Project: “2023 STEMFlex Building Improvement Project”

Subject: Addendum # 1

C EXTERIOR DOOR DETAIL
A8.01 SCALE: 1 1/2" = 1'-0"

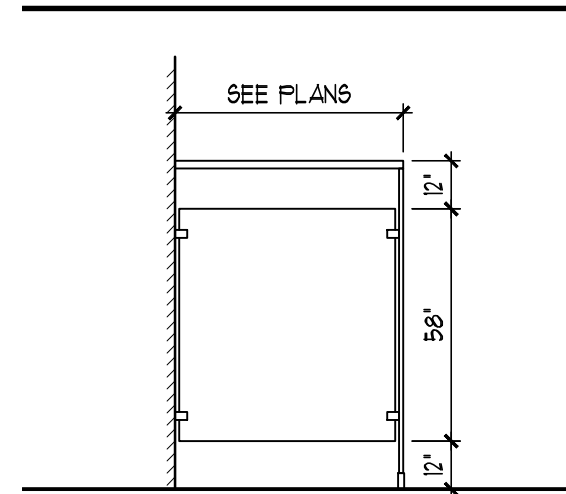
3) The contractor will replace the metal man door (102A), jamb, seal, and hardware on the north side of 1425 Mt Vernon Rd. The new door will have a half glass with no mail slot. See architects attached drawing for details.

DOOR 102A REMOVE EXISTING DOOR AND FRAME
REPLACE WITH HOLLOW METAL FRAME AND DOOR

ENLARGED GROUND FLOOR PLAN

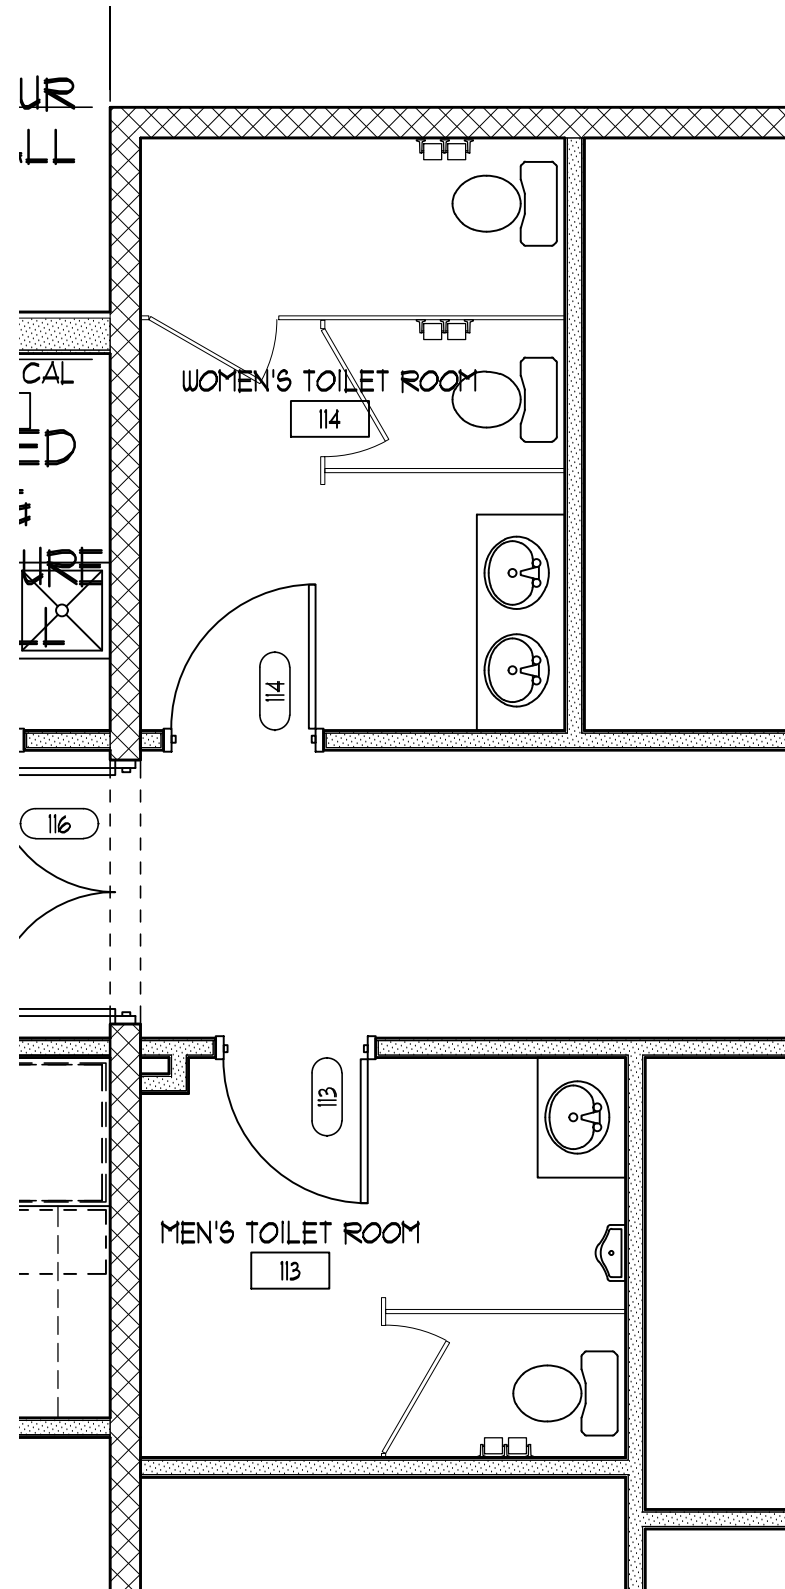
4) The contractor will replace the restroom partition walls in the men’s restroom and in the lady’s restroom of 1425 Mt Vernon Rd. See architects attached drawing for details.

SHEET A4.01 AND A4.02 REPLACE TOILET PARTITIONS IN
ROOMS 113 AND 114

(A6)
TOILET PARTITIONS
POWDER COATED STEEL,
FLOOR ANCHORED/
HEADRAIL BRACED
